Planning Commission

Planning Commission Meeting Agenda
Hartland Township Hall
Thursday, June 27, 2024
7:00 PM

Hartland Township Planning Commission Meeting Agenda Memorandum

Subject: Site Plan PD Application #24-003 Redwood Living Planned Development (PD) Phase II – Preliminary PD Site Plan (**Revised Plans dated June 6, 2024**)

SHEET TITLE: **OPEN SPACE PLAN**
SHEET NUMBER: **C203**

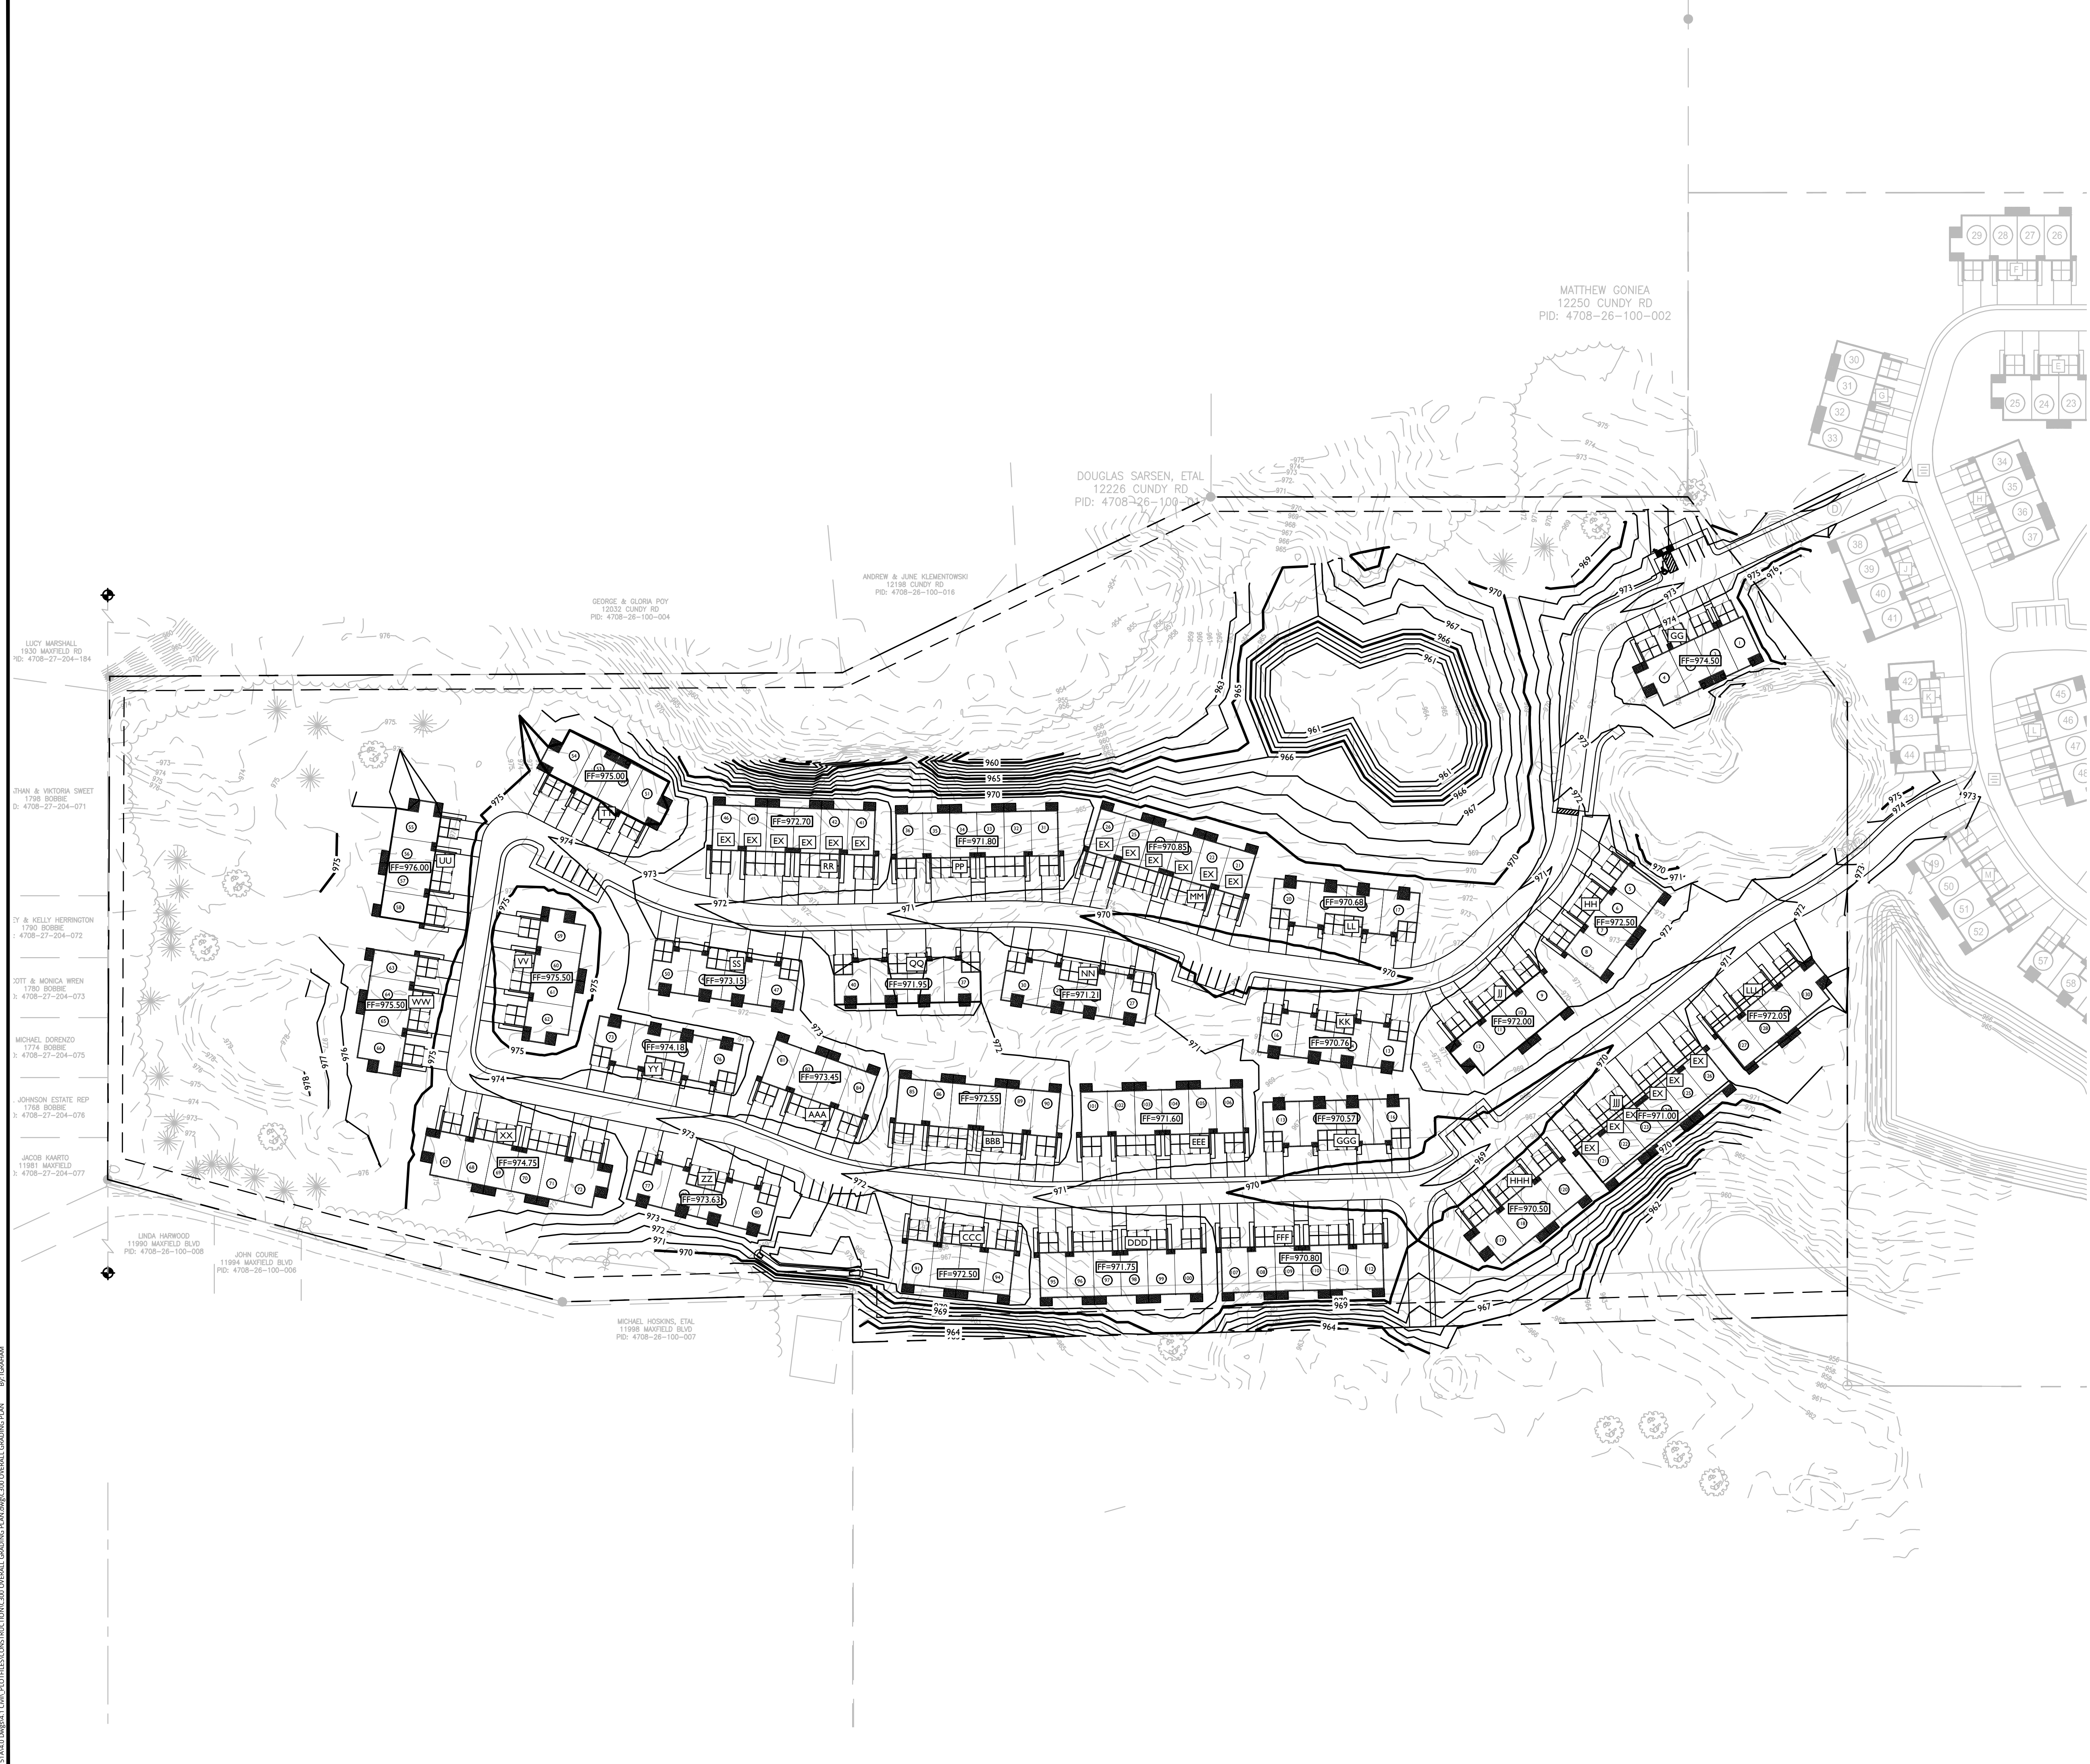
The revised plan set includes an aerial version of the Open Space Plan (Sheet C203, separate document) which includes graphics showing open space areas (black stripes), limits of disturbance (red line), and existing tree preservation limits (blue line).

Sheet C203 in the civil plan set is a black and white version of the aerial plan, without the existing vegetation shown. Open space is shown as striped areas on the plan. Common Open Space areas (or usable open space) are defined by a dashed line, with the area listed for each polygon for a total of 7.71 acres (integral sidewalks are not distinguished with a dashed line on this plan).

A note on the Open Space Plan states “*Existing vegetation between the tree line and limits of disturbance to be evaluated for condition and species. If species and condition of tree is compliant with Township standards, the vegetation shall be protected and preserved*”. This is located on Sheet C203, labeled Open Space Plan.

The Open Space Plan (Sheet C203) states the proposed open space area is approximately 15.74 acres, or 52.6% of the PD, as shown as striped areas on the plan. Sheet C200 states approximately 8.16 acres are dedicated as usable open space, or 27.3% of the site. Those areas include the integral sidewalks (0.45 acres)

and common open space (7.71 acres). The Common Open Space areas are defined by a dashed line on Sheet C203. Wetland areas and the stormwater management area are not counted as open space on the plan.

SHEET NUMBER:
C400

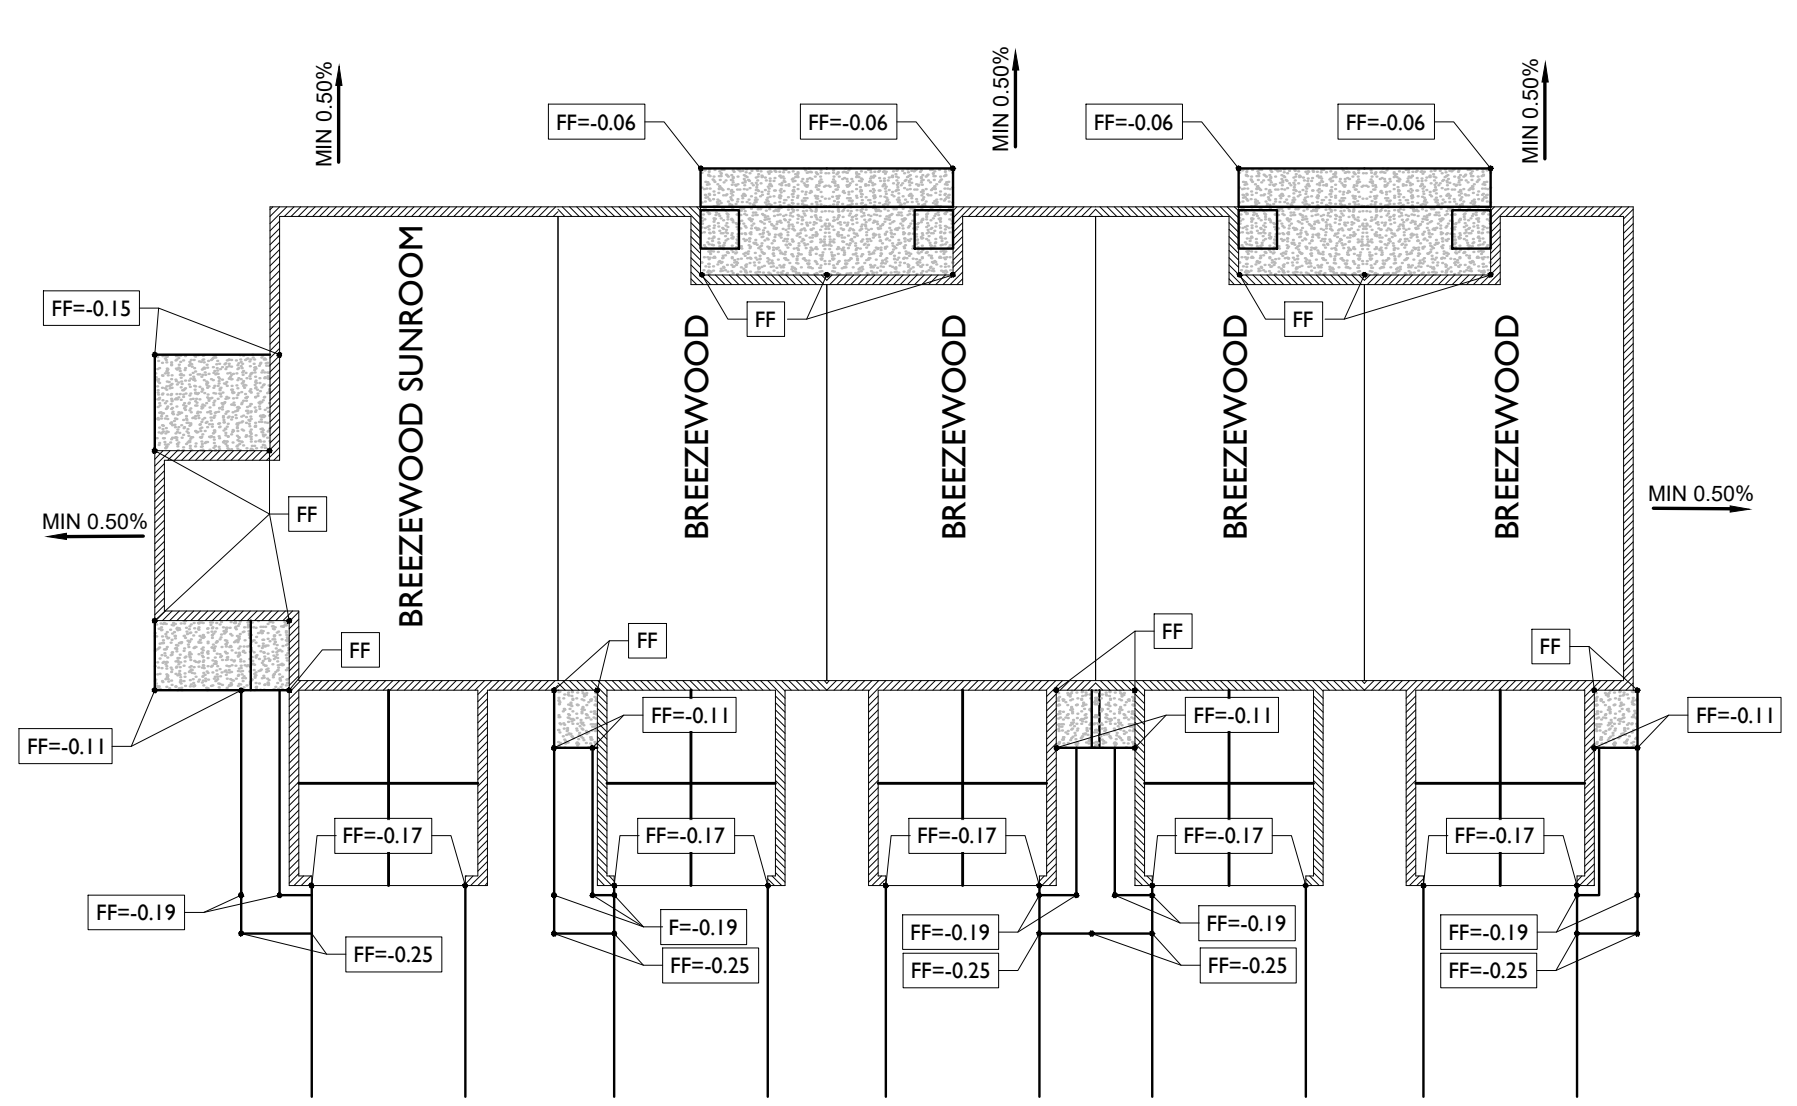
1. Drawing C400: Water main easement shall follow centerline of utility.

1. Drawing C400: Easement missing from sanitary sewer northeast of building A extending into Phase 1.

1 Seed & Sod Plan
SCALE: 1" = 100'

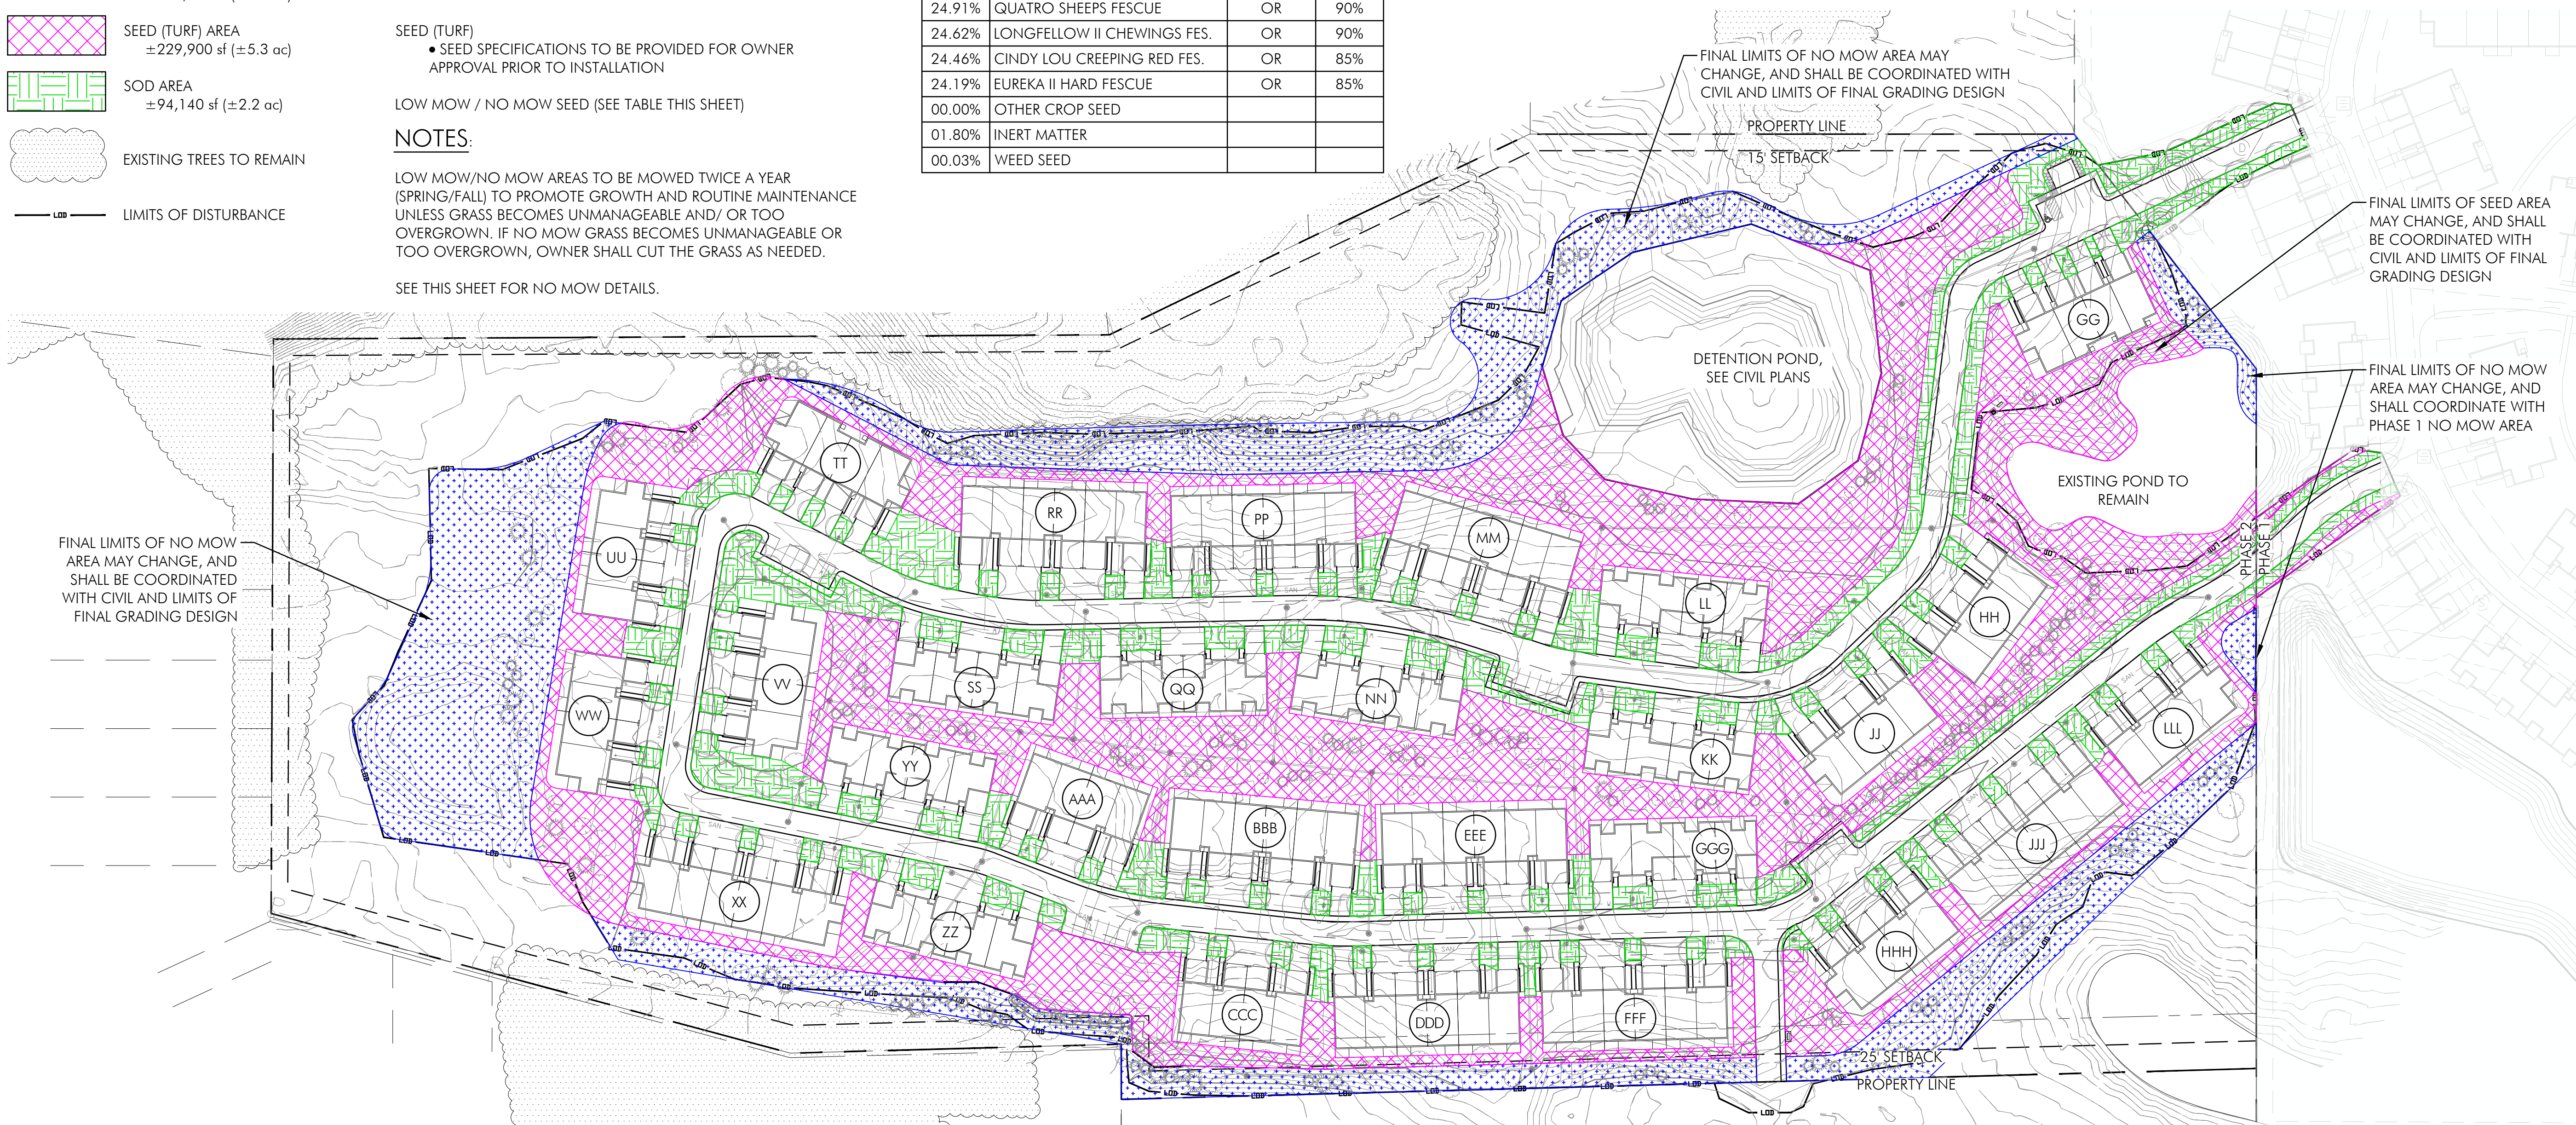
Mowing Plan (Sheet L2.0)
